Title of Change:	Change in carrier tape design for SSOP16 products		
Effective date:	16 March 2018		
Contact information:	Contact your local ON Semiconductor Sales Office or <Kiyoshi.Mita@onsemi.com>, <Hiroaki.Shimizu@onsemi.com>, <Charles.Francia@onsemi.com >		
Type of notification:	This Product Bulletin is for notification purposes only. ON Semiconductor will proceed with implementation of this change upon publication of this Product Bulletin.		
Change category:	☐ Wafer Fab Change ☐ Assembly Change ☐ Test Change ☒ Other <u>Tape and Reel Change</u>		
Change Sub-Category(s):	☐ Manufacturing Site Change/Addition ☐ Material Change ☐ Datasheet/Product Doc change ☐ Manufacturing Process Change ☐ Product specific change ☒ Shipping/Packaging/Marking ☐ Other: _____		
Sites Affected:	ON Semiconductor Sites: ON Tarlac City, Philippines	External Foundry/Subcon Sites: None

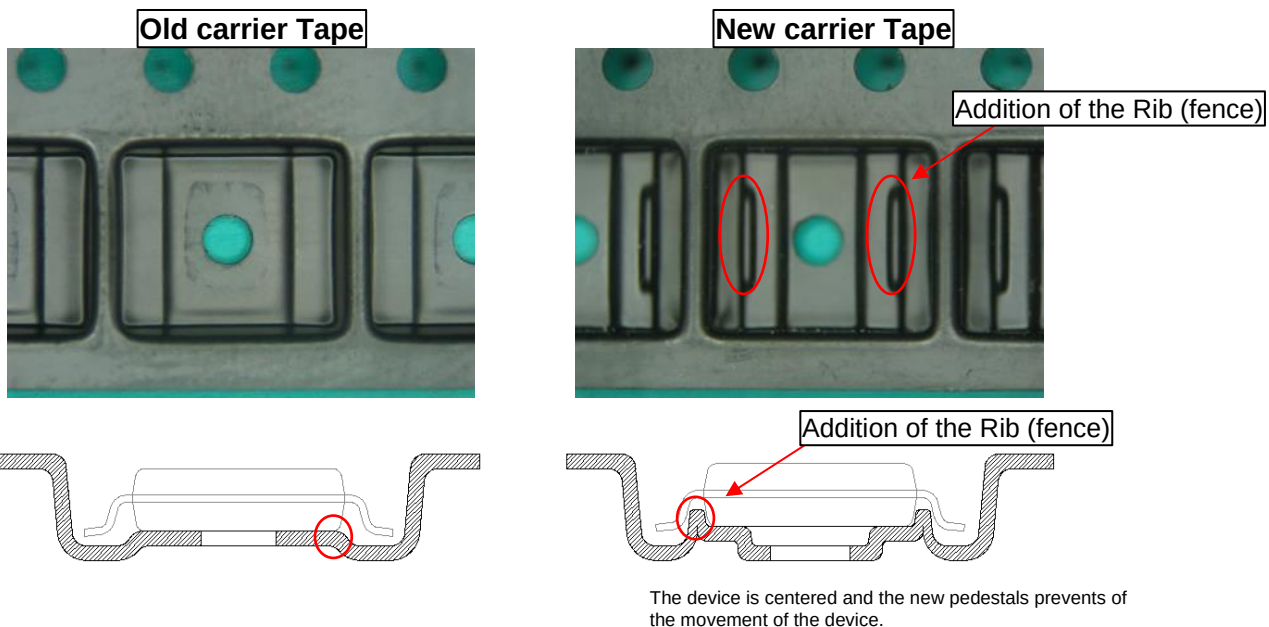
The purpose of the new design is to minimize the movement of the devices inside the pockets of the reel.

Rib (fence) were provided in the pocket to suppress movement of the device.

The reel being used in the process and the new designed reel were compared and the photos are shown below:
